CPCI J1

PCIE TO PCI BRIDGE

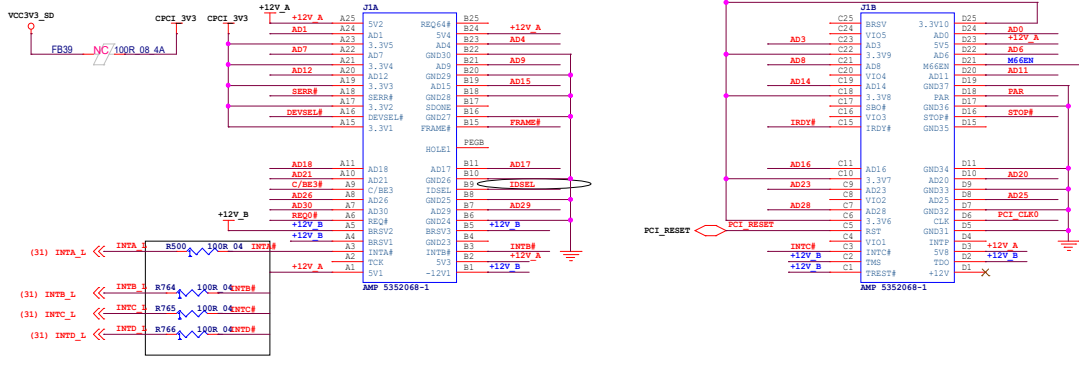
电阻换成100R\_0 4 0 2

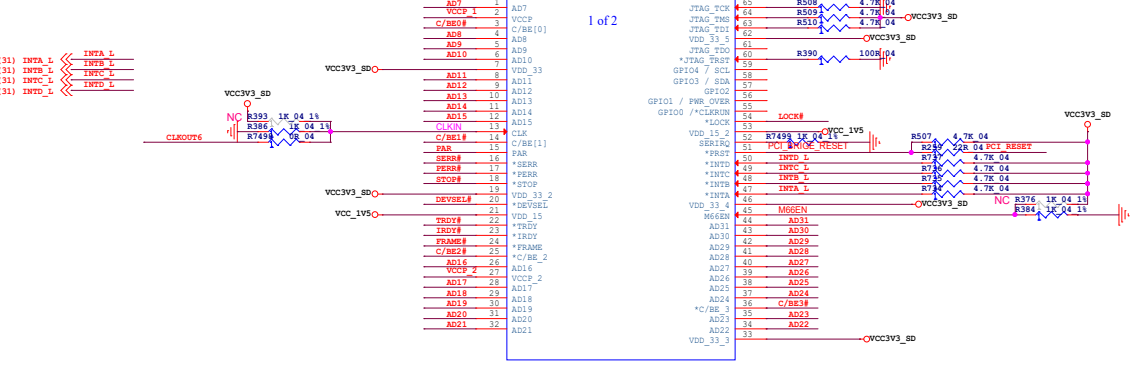
采用内部时钟源
